**Request for Bids from interested and qualified
Vendors to provide the University of Arizona
Customized Electronic Linear Actuator
Mechanisms.**

ADDENDUM #1

**Sealed RFB # S262201
Due on April 8, 2022, no later than 2:00 PM, MST**

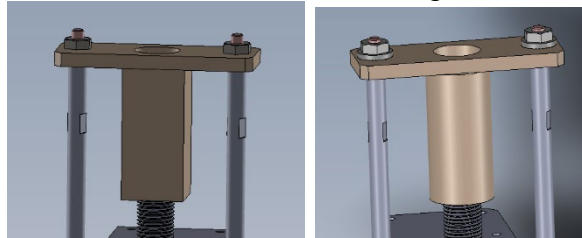
7. How do you want to attach the load to the actuator?
- We can extend the threads on the guides or add features to the Tee Nut. What is desired.

8. Cost versus weight issues:
- While it appears logical to focus on component cost, there is a cost per pound to put the components into orbit. Since we have no information about the launch costs, we can't make cost-based decision in the unit design.

- The T nut assembly as shown is made from a metal plate. It is less expensive to make the nut portion square, however if the extra cost of making the nut round is incurred, the weight of that part is reduced approximately 25%. In addition, the length of the assembly is a bit shorter if the nut is round because the corners interfere with the mounting, this adds more weight. There may be other weight reduction options; Is there a launch cost per pound that can be used to determine if weight reductions result in cost savings?

Answer: The T-nut will have a central boss and two bolt holes that will be attached from the rear.

Answer: There is no definition in the RFB that this component will be launched/ in orbit. There are no launch costs to consider.

Answer: The very long rods shown will probably not meet the resolution requirement. Backlash can be ignored because the actuator system design has a preload, but the windup of the rods when the acme screw turns cannot be ignored.

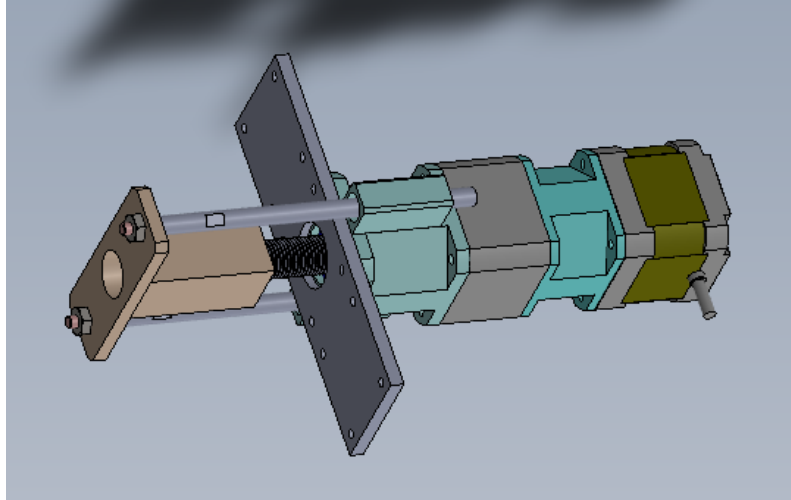
9. The plate that is shown is our guess at the mounting configuration, it is not part of the assembly. Do we need to adjust anything?

Answer: The flange of the gearbox as shown is a good mounting scheme. It needs to be accessible from below.
